REVIEW OF APPLICATION FOR CERTIFICATION OF COLLINS HYDROELECTRIC PROJECT

This report provides review findings and recommendations related to the application submitted to the Low Impact Hydropower Institute (LIHI) on June 1, 2011 by Swift River Company (Applicant) for Low Impact Hydropower Certification of the Collins Hydroelectric Project (the Project).

Figure 4. Project layout. (Source: 2001 FERC inspection report)

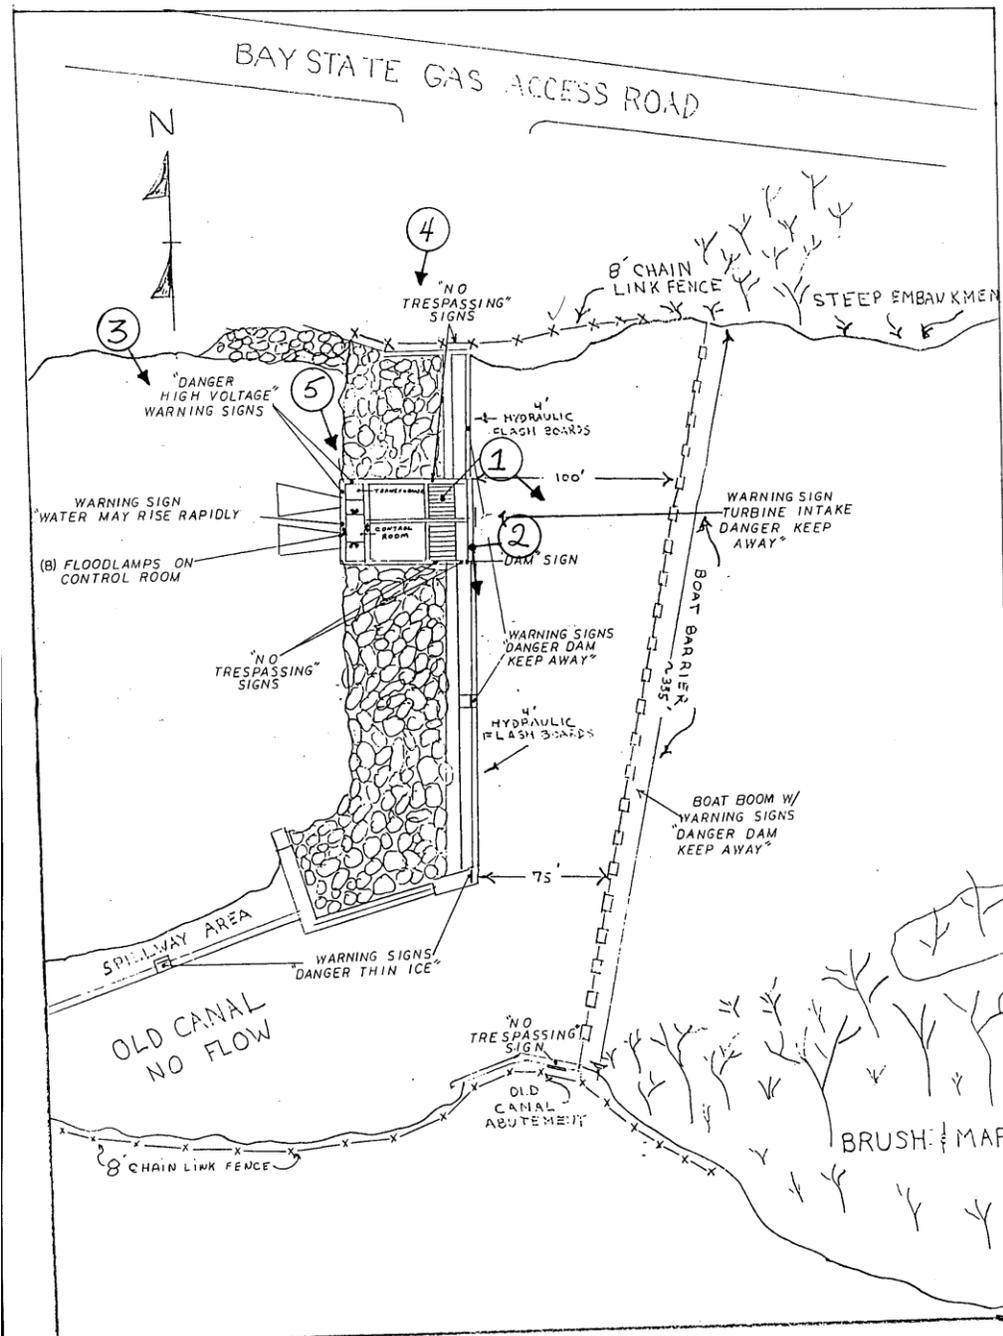
11. The exemption describes the project as having a flashboards crest elevation of 223.4 feet and a flashboard height of 3.0 feet. The FERC inspection reports in your Appendix B state 222.1 feet and 4.0 feet, respectively. Is there an explanation for the discrepancy? **At the time the exemption was issued, the design was not finalized. The numbers in appendix B are correct: the project has 4 feet of flashboards that are lowered when flows exceed the crest discharge limitations.**

Figure 8. Hydrograph showing peaking flow fluctuations downstream of Indian Orchard Dam.

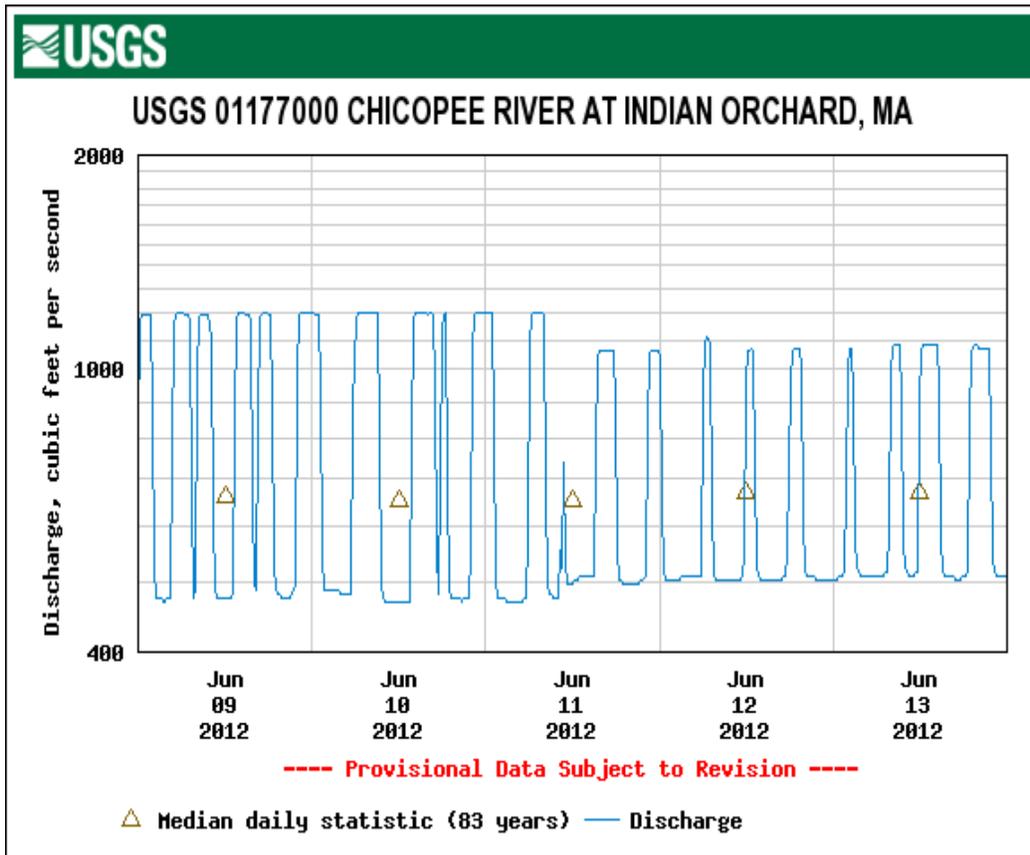
The Chicopee River drains an area of 682 square miles at the dam site. The Collins station operates in a run-of-river mode over a range of flows up to 1,200 cfs. According to a FERC inspection report from 2001, the station is automated to run off of a headpond water level sensor, shutting the station down when the level drops to 0.25 foot below the top of the flashboards and returning it to service when level rises to the top of the boards. Operation is in tandem with releases from the upstream Red Bridge Hydroelectric Project (FERC No. 10676), which operates in a peaking mode. Figure 8 below displays data from the U.S. Geological Survey river gage (drainage area 689 square miles) located about five miles downstream of Collins (0.6 mile below Indian Orchard Dam) and illustrates the cycling caused by the Red Bridge operation.
